Re: NCIRT Review and USACE Approval of the Catfish Pond Mitigation Plan; SAW-2018-00424;
NCDMS Project # 100039

RE: Response to IRT comments on Draft Final Mitigation Plan Submittal
Catfish Pond Mitigation Site, Durham County, NC
Neuse River Basin - 03020201
DMS Project ID No. 100039 / DEQ Contract #007424

Catfish Pond Mitigation Plan Comments

RE: Response to DWR comments on Draft Final Buffer Mitigation Plan Submittal
Catfish Pond Mitigation Site, Durham County, NC
Neuse River Basin - 03020201
DMS Project ID No. 100039 / DEQ Contract # 007424

Catfish Pond Mitigation Site
 Durham County, North Carolina
 Planting Overview
 Planting and Fencing Plan

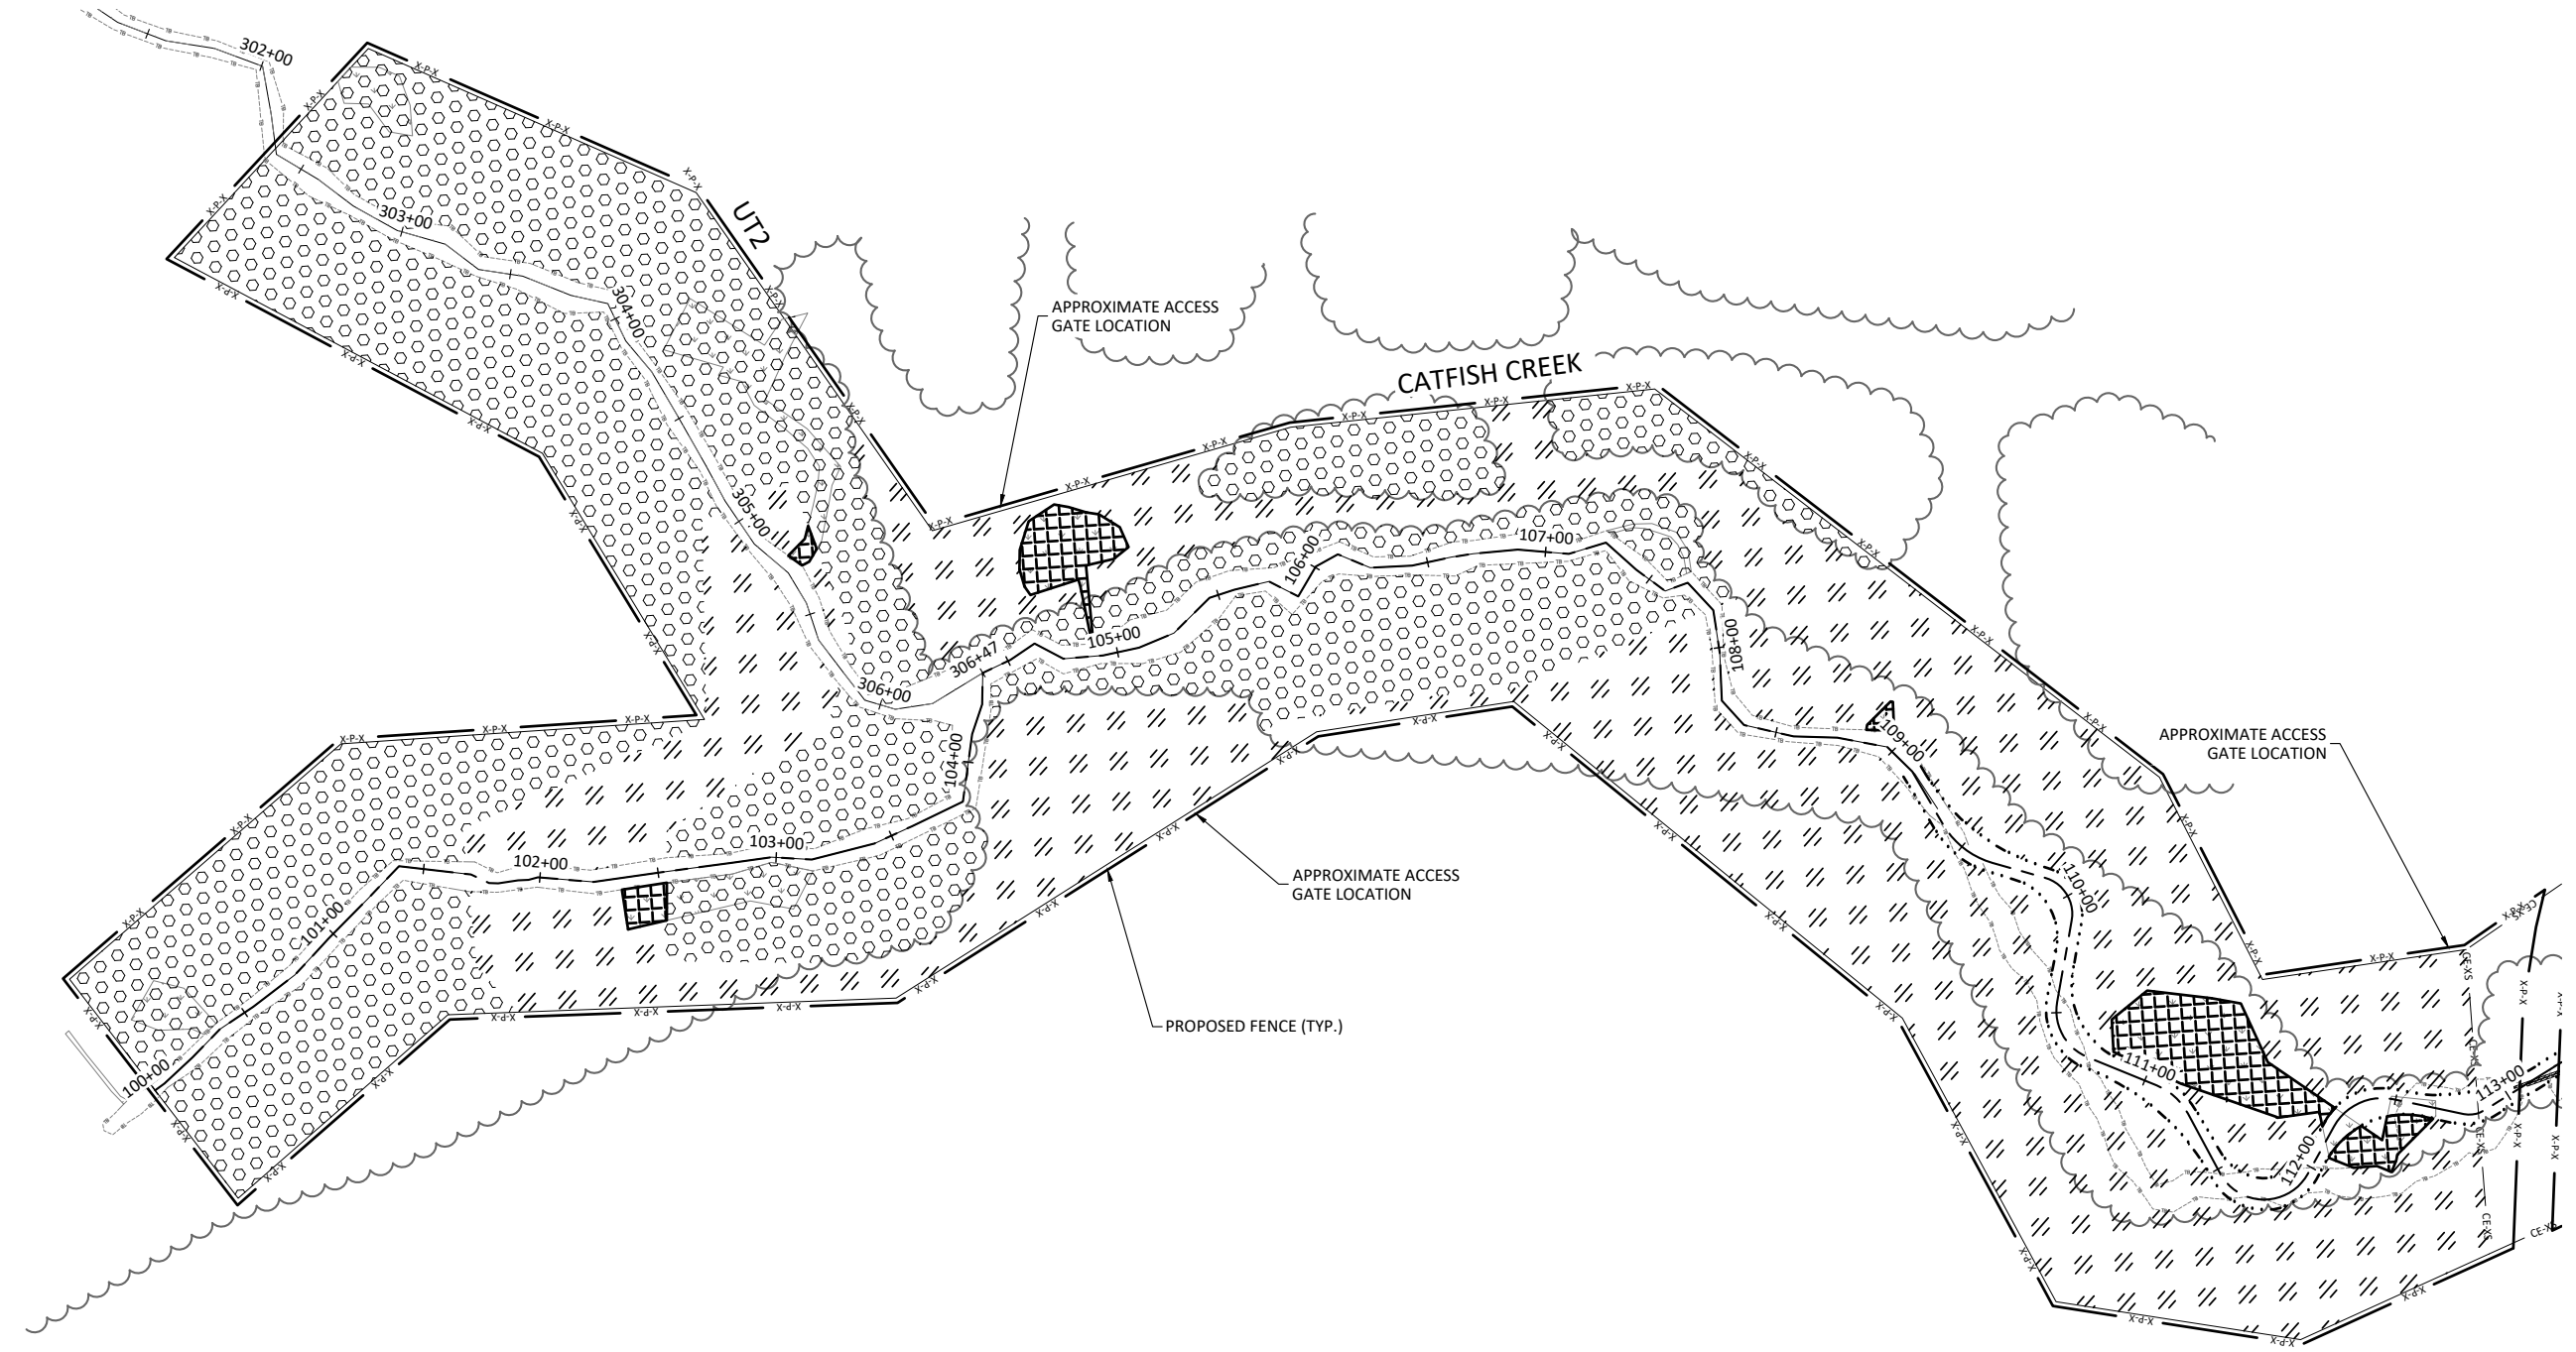
2. *Plan Sheet 5.0: The list of planned species to be planted is not legible.*
